**OFFICE OF NEW REACTORS**  
**SUMMARY FEEDBACK ON FOUR KEY LICENSING ISSUES**  
**NEXT GENERATION NUCLEAR PLANT**  
**PROJECT 0748**

**Figure 1.** NGNP Frequency-Consequence curve proposed by DOE/INL (ML12262A090)

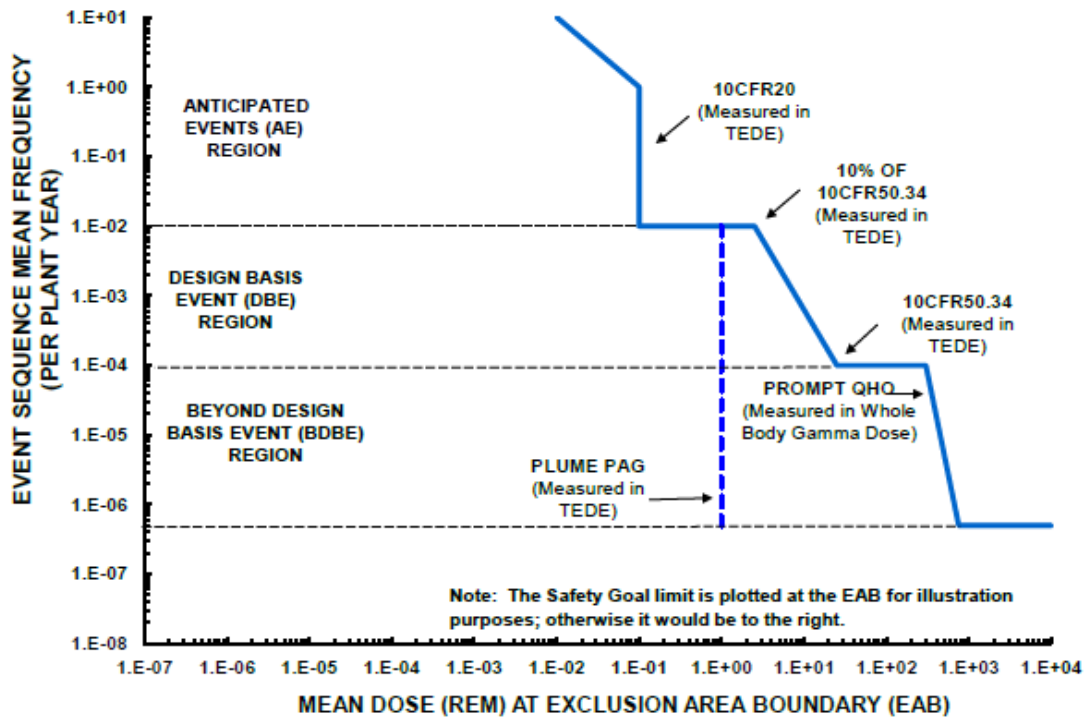
The NRC staff concludes that the proposed approach to placing top level regulatory criteria (TLRC) on a frequency-consequence (F-C) curve is reasonable. Figure 1, a copy of DOE/INL's proposed F-C curve, identifies the regulatory bases for the respective TLRC and displays the TLRC-based dose limits as a function of event sequence mean frequency over the proposed event category regions.

The proposed FC-curve's event category regions and their respective TLRC bases are summarized as follows:

- The TLRC for the AE region would be based on limiting the annual dose to an individual member of the public to 100 millirem total effective dose equivalent (TEDE) as required in 10 CFR Part 20, "Standards for Protection against Radiation." DOE/INL proposes that AE source terms should be mechanistically modeled and that dose consequences should be realistically calculated at the exclusion area boundary (EAB).

- The TLRC for the DBE region would be based on an event-based public dose criterion of 25 rem TEDE as required in 10 CFR 50.34, "Contents of Applications; Technical Information."<sup>7</sup> DOE/INL proposes that DBE source terms should be mechanistically modeled and that dose consequences should be conservatively calculated at the EAB.

- The TLRC for the BDBE region would be based on cumulative public dose limits derived from the quantitative health objectives (QHOs) of the NRC safety goals, whereby the QHO for prompt fatality is the most limiting. DOE/INL proposes that BDBE source terms should be mechanistically modeled and that offsite dose consequences should be realistically calculated.
